Service Bulletin

NO. 337

Studebaker and Packard

Fig. 1

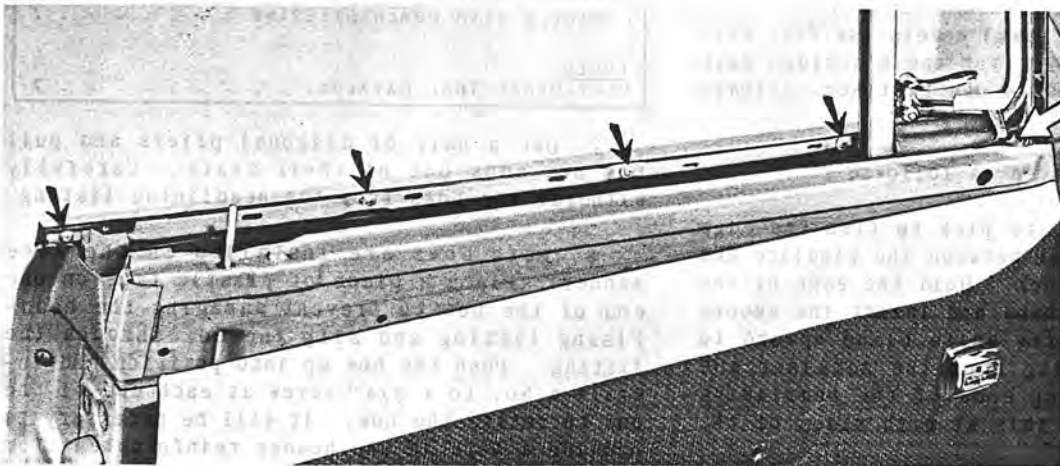
Remove the window lower stop and bracket assembly. Then, lower the window as required to permit removal of the window weatherseal (fuzz strip). Remove the weatherseal. Then, remove the front screw below the ventilator window, turn back the rubber ventilator weatherstrip which will expose a hole to provide access to the front screw. (See Fig. 1) Note: This screw is different from the other moulding

screws in that it is a course thread screw. Then remove the remaining screws indicated by the arrows and remove the moulding.

Fig. 2

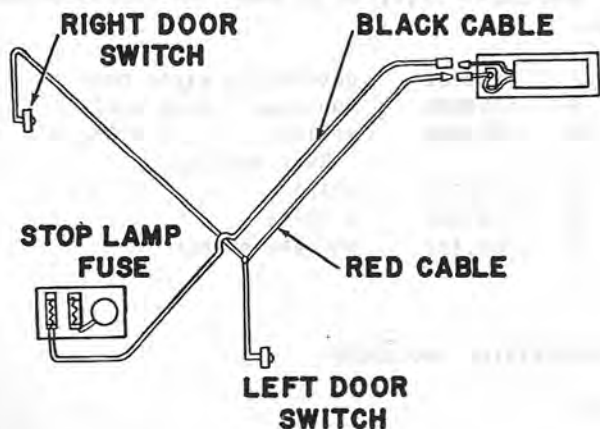
8. Connect the black cable end to the terminal on the fuse block. See Fig. 2. Use screw, Part No. G-122159 and lock washer, Part No. 121752.

Fig. 3

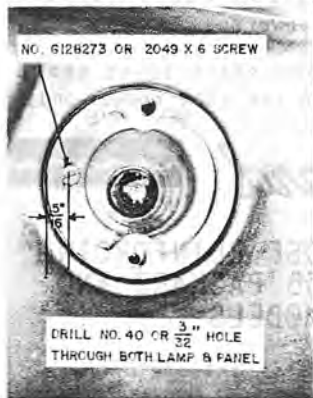
A condition of poor ground can be corrected by the installation of a No. G128273 or 2049x6 Screw at a point 5/16" from the outer edge of the light housing as shown in Fig. 3.

A condition of water in the light housing can be corrected by the use of electrician's tape, applied at the points indicated by the arrows in Fig. 4. The lens gasket should also be checked for proper installation.
